MFN No. 052-93  
Docket STN 52-004

Subject: NRC Requests for Additional Information (RAIs) on the Simplified  
Boiling Water Reactor (SBWR) Design

Enclosure: RAI Responses

Figure 1

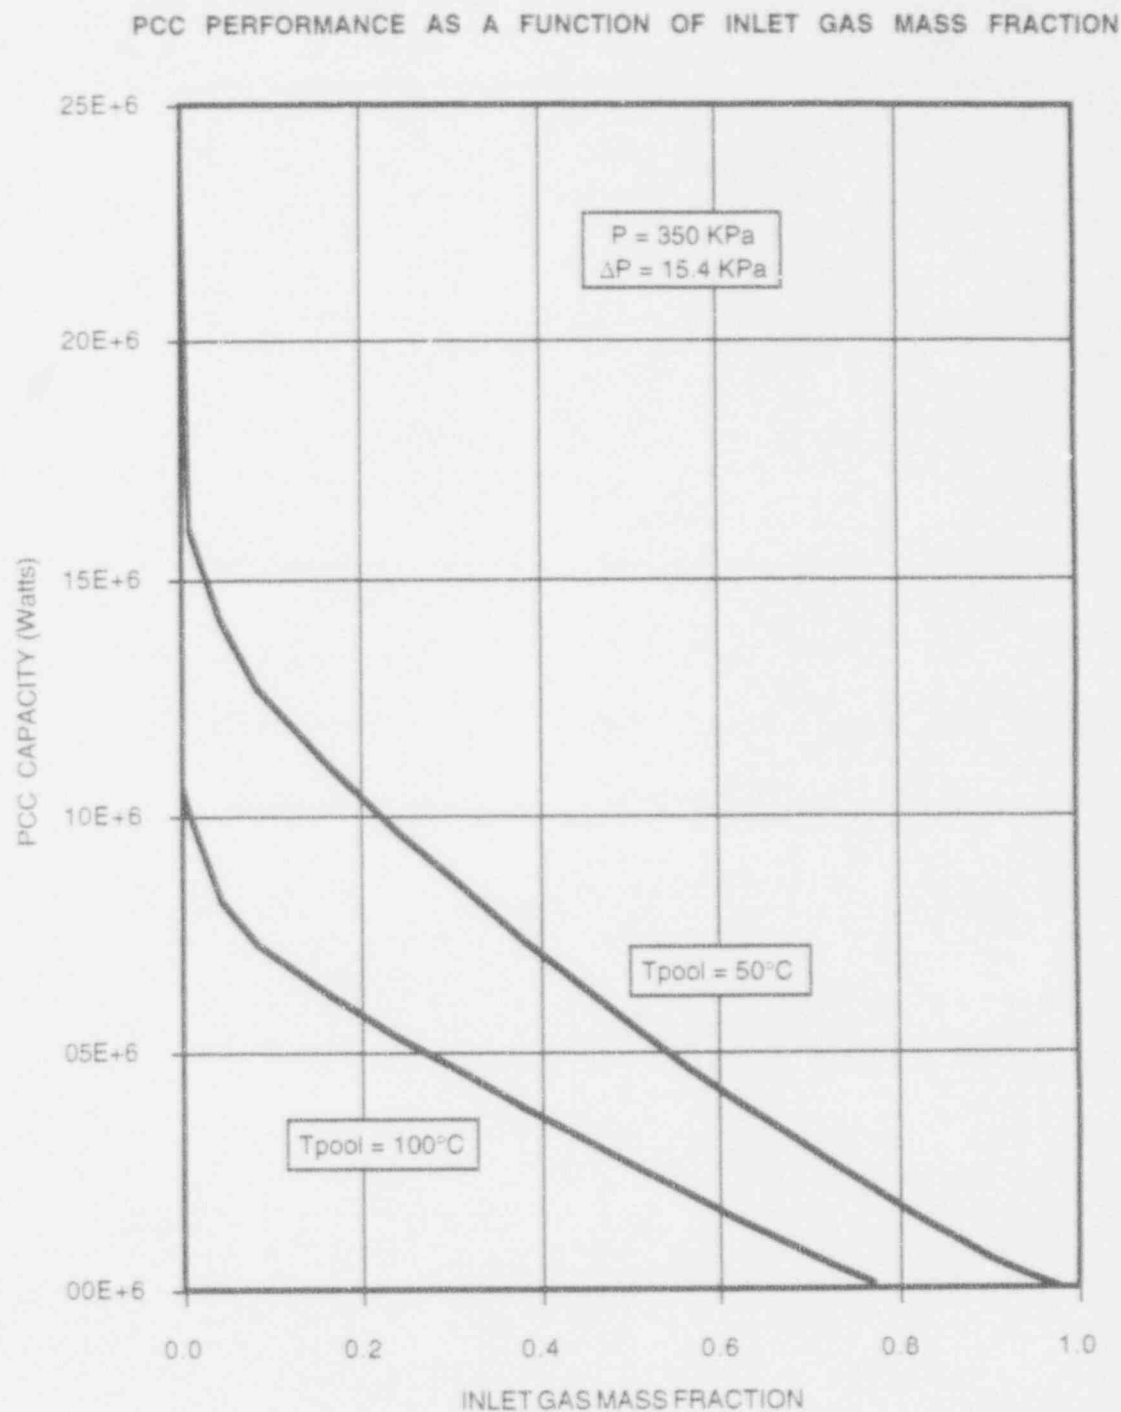
How does the basic PCCS capacity defined in Question RES.1 decrease as the noncondensable gas fraction at the PCCS inlet increases?

The variation of the heat removal rate of the PCCS condenser with inlet noncondensable gas mass fraction was determined for a drywell pressure of 350 kPa and a drywell-to-suppression chamber pressure differential of 15.4 kPa. The results for IC/PCC pool temperatures of 50 and 100°C are given in Tables 1 and 2, respectively. The corresponding results are shown in Figure 1.
